## **847-855 Kingston Road – Official Plan and Zoning By-law Amendment Application – Appeal Report**

Date: March 18, 2025  
To: Toronto and East York Community Council  
From: Director, Community Planning, Toronto and East York District  
Ward: 19 - Beaches-East York

**Planning Application Number:** 15 171595 STE 32 OZ

Site Plan

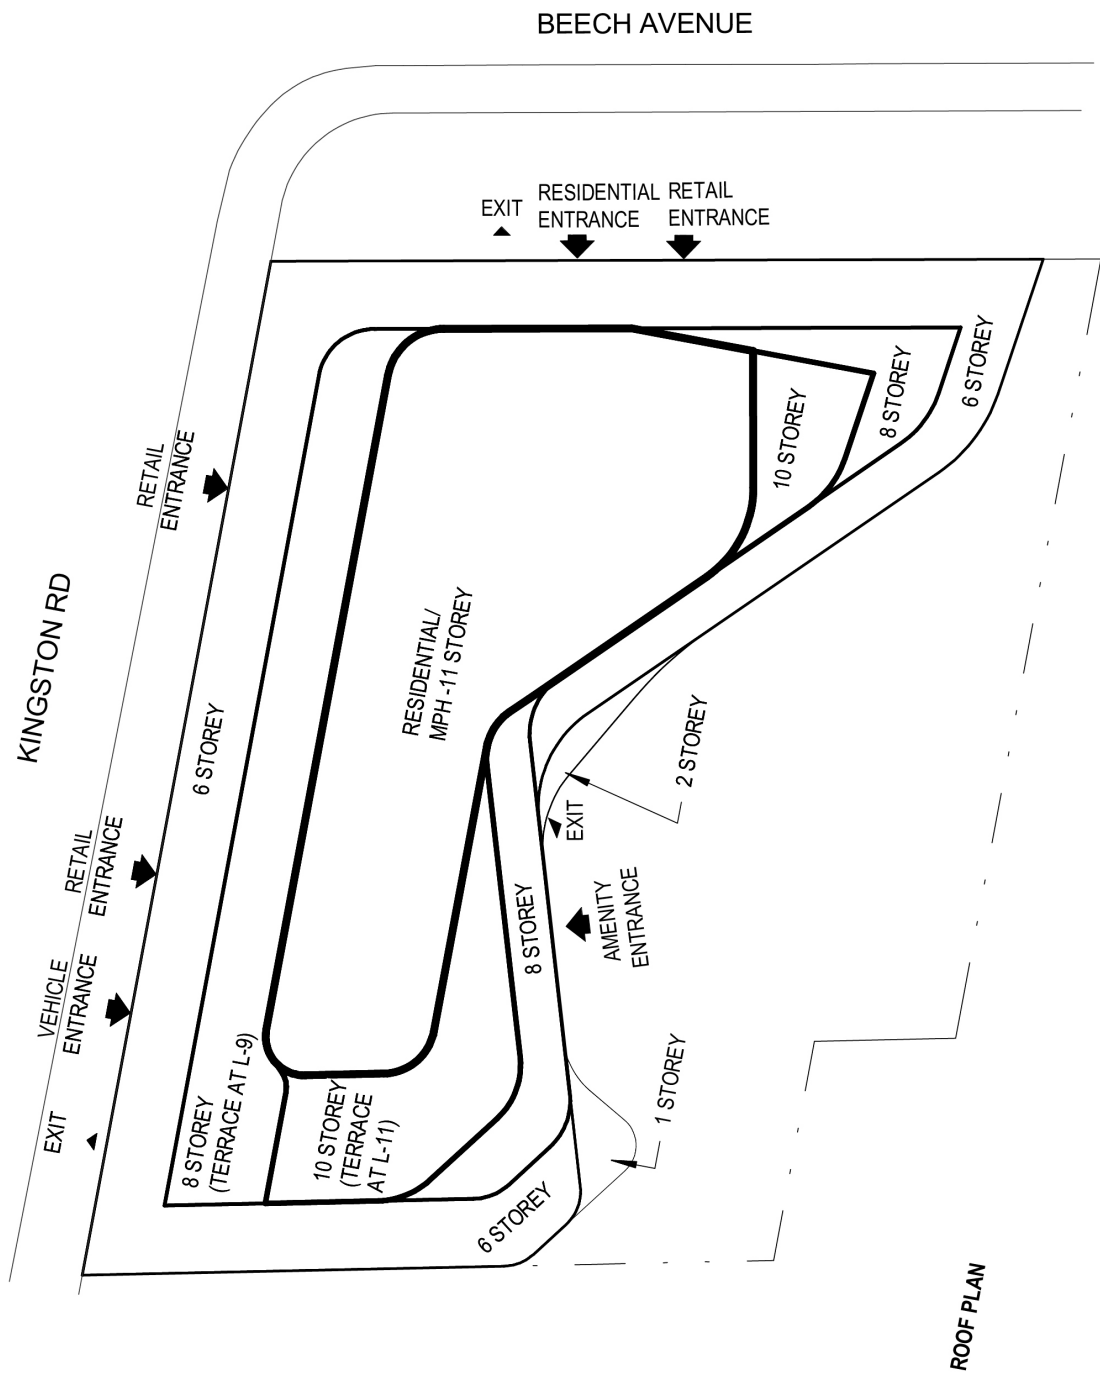
The proposal does not provide an adequate development setback from the erosion hazard associated with the Glen Stewart Ravine. A zero-metre setback from long term stable top of slope is currently proposed where the Official Plan and TRCA policy requires a minimum 10 metre setback. Additionally, the current proposal does not satisfy TRCA policy and provide an erosion access allowance TRCA policy. The erosion access allowance is a horizontal allowance that provides emergency access to the erosion hazard, construction access for maintenance and emergencies, and protection against unforeseen or predicted external conditions.

The site includes sensitive natural heritage features to the west and south which require consideration in terms of setbacks and massing. The nature and extent of the slope on the Glen Stewart Ravine constrains where a structure may be located. The building coverage includes a large portion of the lot and encroaches into the setbacks from the long term stable top of slope.

There are two levels of below grade parking from which the base of the building rises. The second floor cantilevers over the base of the building at the north and south side and proposes no setbacks until the seventh floor, providing an intrusive streetwall along Kingston Road and further encroaching into the natural heritage feature setback at the rear and west side of the site. The built form requires revisions to fit within the constraints of the site including an appropriate streetwall height. Staff consider the proposed built form and massing as overdevelopment given the context and site constraints.

The building is proposed to be setback approximately 2 metres from the north (front) property line, providing a 4.6 metre distance from building face to curb along the south side of Kingston Road. Along the western side of the front property line, a slightly larger front setback of 2.4 metres is proposed, providing for a 5 metre curb to building face setback.

The City's Mid-Rise Design Guidelines encourage a minimum of a 6 metre setback from building face to curb along primary streets to provide space for public realm improvements such as large-growing trees, street furniture, bicycle infrastructure, Toronto Transit Commission (TTC) shelters, and a 2.1 metre unobstructed pedestrian clearway. The current proposal also cantilevers back out into the public realm above the setback on the second floor, which impacts space for street tree canopy. The TTC has indicated that the streetscape will need to be reconfigured to accommodate a bus shelter. Given the information available to staff as of the date of this report, it is not clear whether a bus shelter and pedestrian clearway within the current front setback could be accommodated.

Staff have also requested that vehicular access be relocated from Kingston Road to Beech Avenue to allow for a continuous boulevard and pedestrian clearway with soft landscaping and trees along Kingston Road.

Vehicular access to the parking garage and internalized loading space will be off Kingston Road. Transportation staff have indicated the access location is not acceptable and should be relocated to Beech Avenue to improve safety and provide a continuous and active retail frontage along Kingston Road.
